# Service Bulletin

Bulletin No.: PIC5922A

**Subject:** Revised Front License Plate Bracket Installation Instructions

**Models:** 2014 Cadillac CTS Sedan  
with Front License Plate Mounting Package (RPO VK3)

Revised License Plate Bracket Installation Instructions

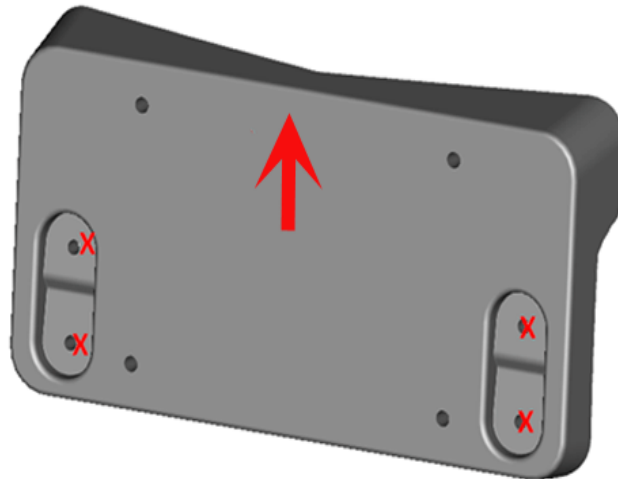
The installation of the front license plate bracket (if equipped) has been revised for better retention. Do NOT use the rivets included in the trunk bag for installing the Front License Plate Mounting Package (RPO VK3). If bolts and u-nuts are included in the trunk (small package with instruction sheet), use those to install the bracket following the instructions below. If bolts and u-nuts are not in the trunk, order four (4) bolts and four (4) nuts to install the front bracket. Reference Parts Information section below.

3631355

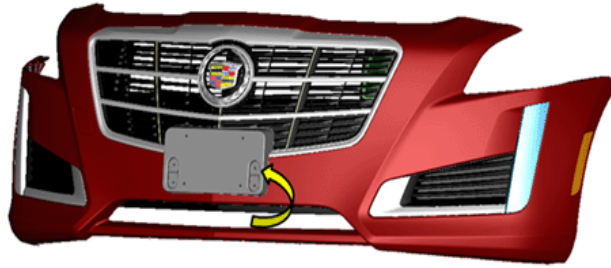
1. Drill 5.0 mm holes in all 4 location holes in bracket marked "X."

2. Install bolts through the license plate bracket and fascia holes.

3. Reach inside and behind the fascia (through the lower fascia opening) and install u-nuts on the backside. The u-nut is being used only as a nut, it does not clip on to any body parts.
4. Tighten bolts into u-nuts with a torque of (22 in lbs.) or (2.5 nm.).
